RE: SUB 2001-102 -- One-Step Final Plat of Allen Elementary School Addition

RE: SUB 2001-102 -- One-Step Final Plat of Allen Elementary School Addition

CASE NUMBER: SUB 2001-102 -- ALLEN ELEMENTARY SCHOOL ADDITION

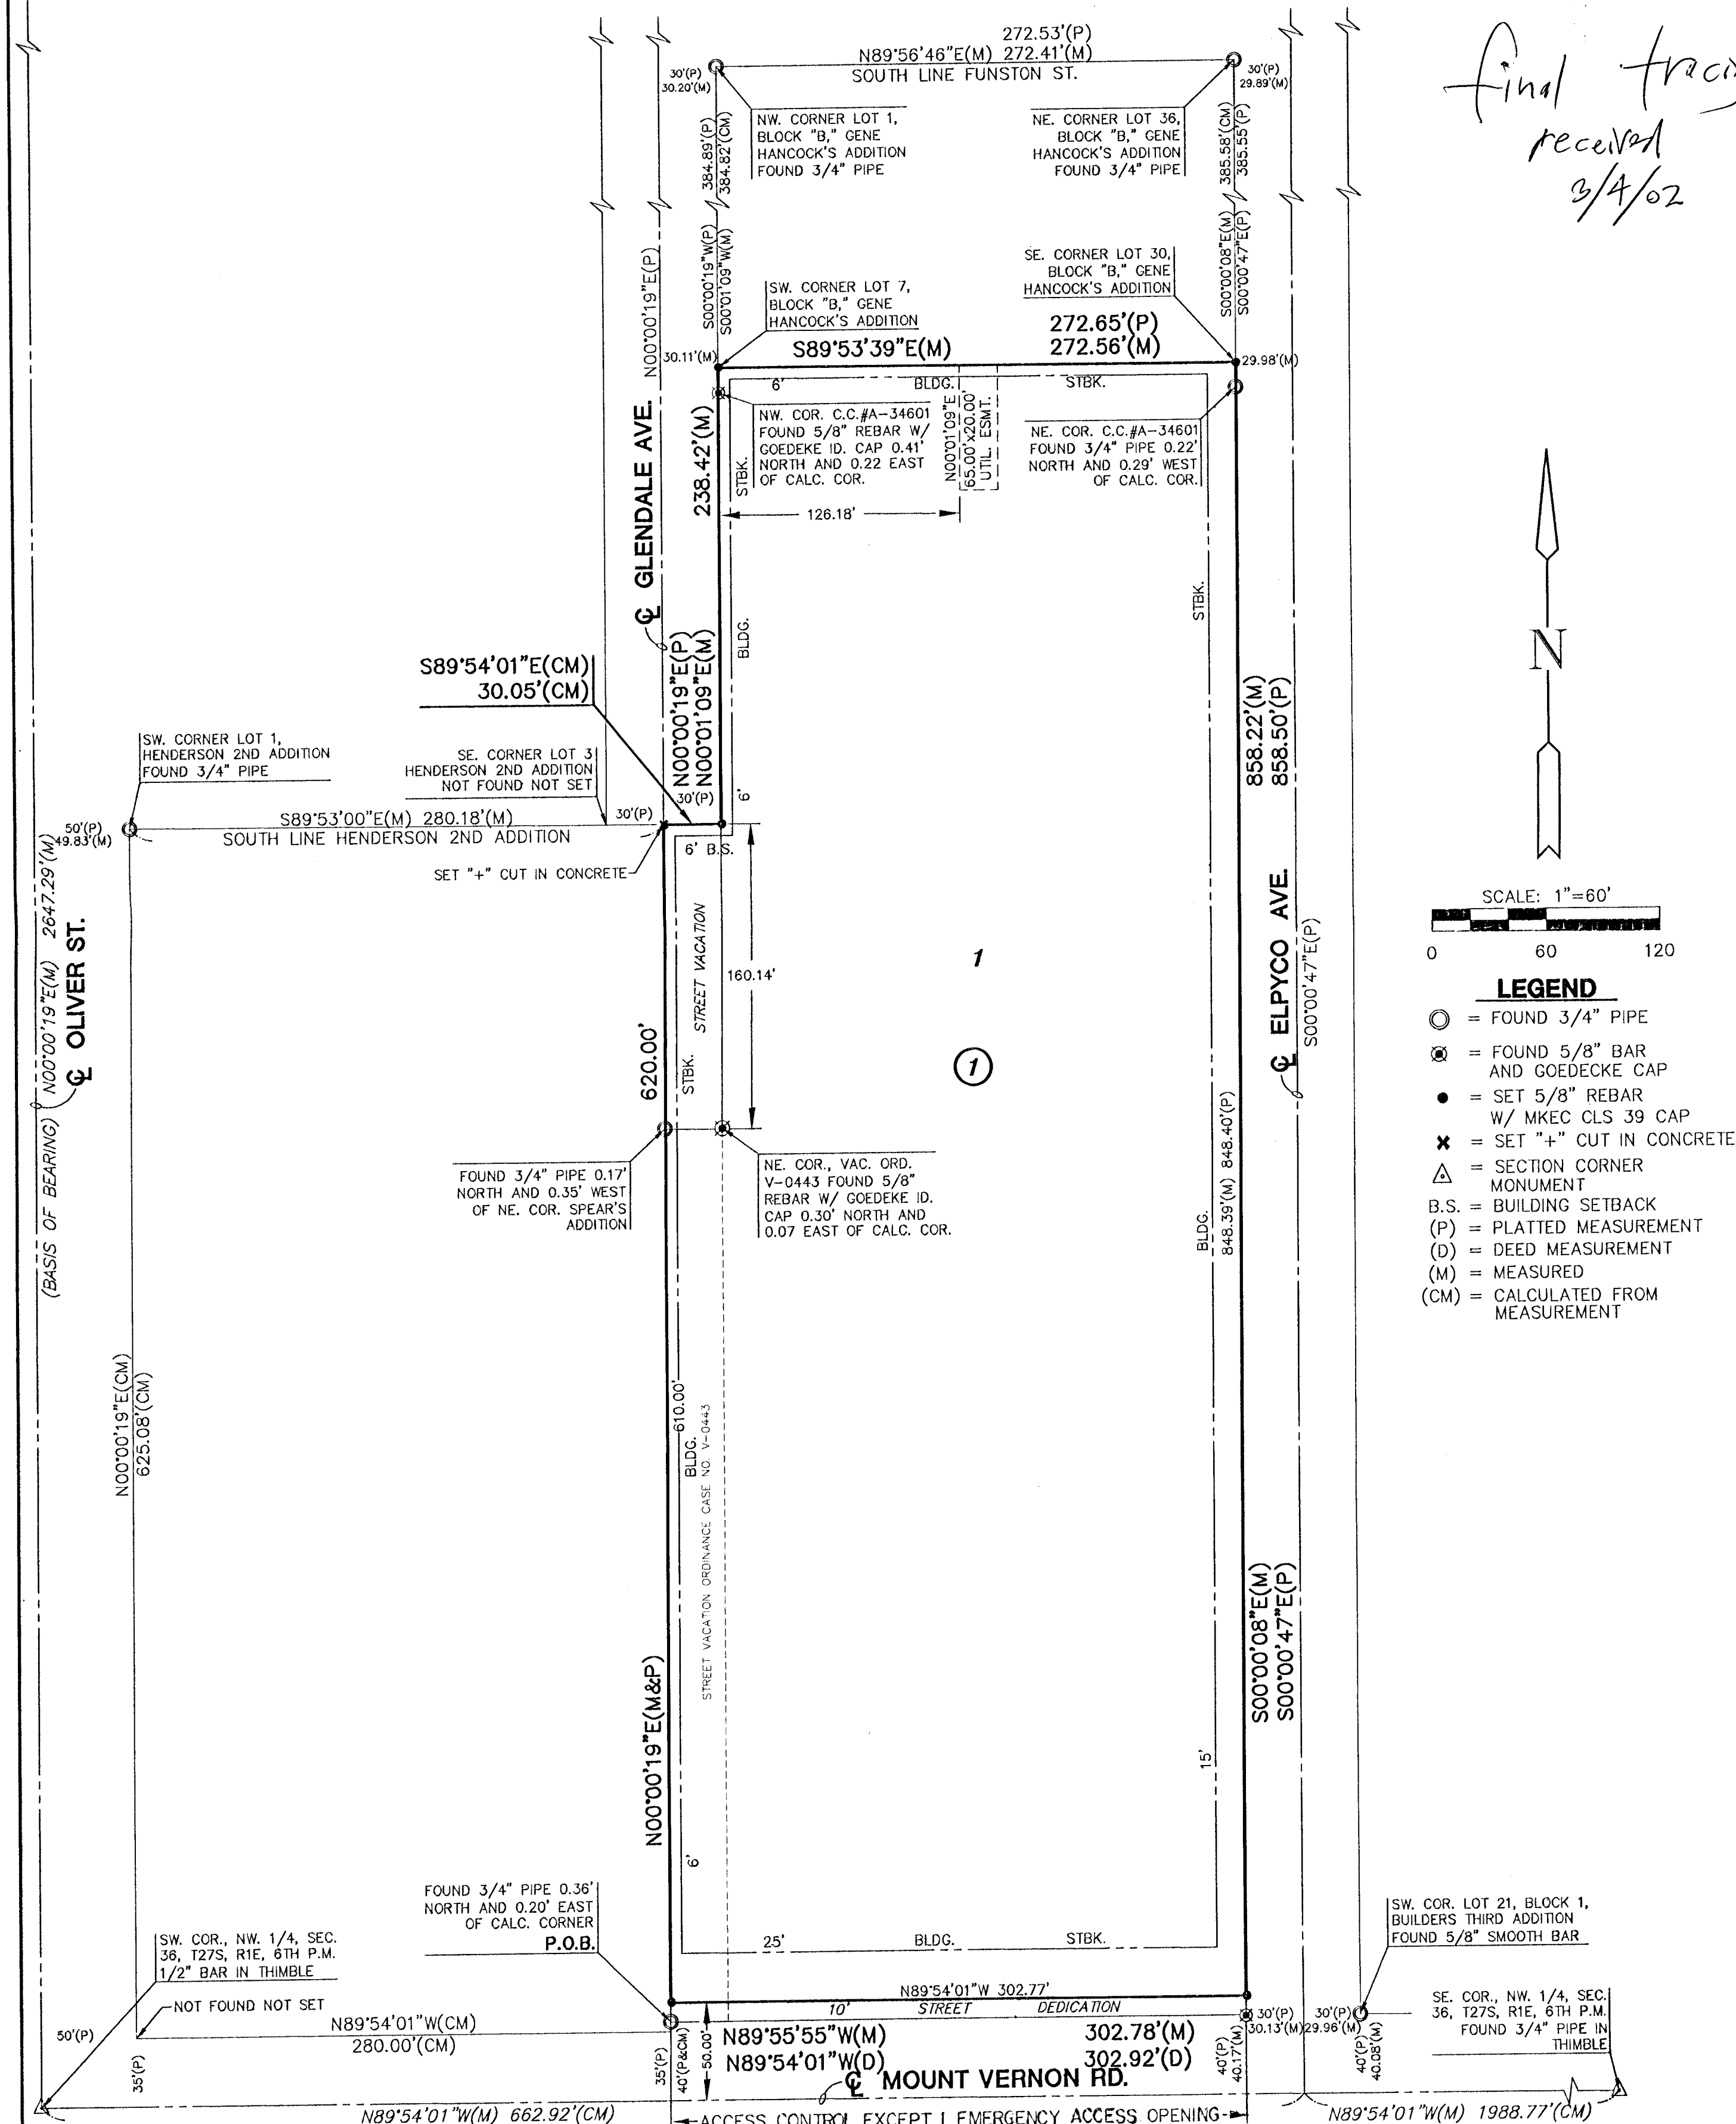
- A. Municipal services are available to serve the site. City Engineering needs to comment on the need for guarantees or easements. The north-south utility easement extending from the north property line needs to be reduced.

- C. City Engineering needs to comment on the status of the applicant's drainage plan. The drainage plan is approved.
- D. Traffic Engineering needs to comment on the need for additional right-of-way for Mt. Vernon which is designated as an arterial. The plat's text shall note the dedication of the streets to and for the use of the public. The applicant shall dedicate an additional 10 feet of right-of-way.

- E. Traffic Engineering needs to comment on the access controls. The plat proposes two access openings along Mt. Vernon and an emergency access. Traffic Engineering and MAPD have recommended complete access control along Mt Vernon Road, with the exception of an emergency access opening.

- F. A guarantee shall be submitted assuring the construction of an all-weather roadway surface for the emergency access easement. The text of the instrument shall indicate the type of driving surface to be installed and address installation and maintenance. Standard gating and signing are required per County Fire Department standards.

- H. On the final plat, the MAPC signature block needs to reference "J.D. Michaelis, Chair".
- I. Approval of this plat will require a waiver of the lot depth to width ratio of the Subdivision Regulations. The Subdivision Regulations state that the maximum depth of all residential lots shall not exceed 2.5 times the width. A modification has been approved by the Subdivision Committee.

- J. If determined to be part of the Glendale right-of-way, the Applicant shall contact the adjoining property owner to the west regarding the proposed vacation of right-of-way for Glendale Avenue. A vacation case shall be approved before the approval of the plat. If no off-site right-of-way for Glendale exists, the portion of Glendale as depicted within the site may be vacated through the plat. The applicant shall dedicate additional right-of-way to obtain a 30-ft wide "L"-type turnaround for Glendale Avenue.
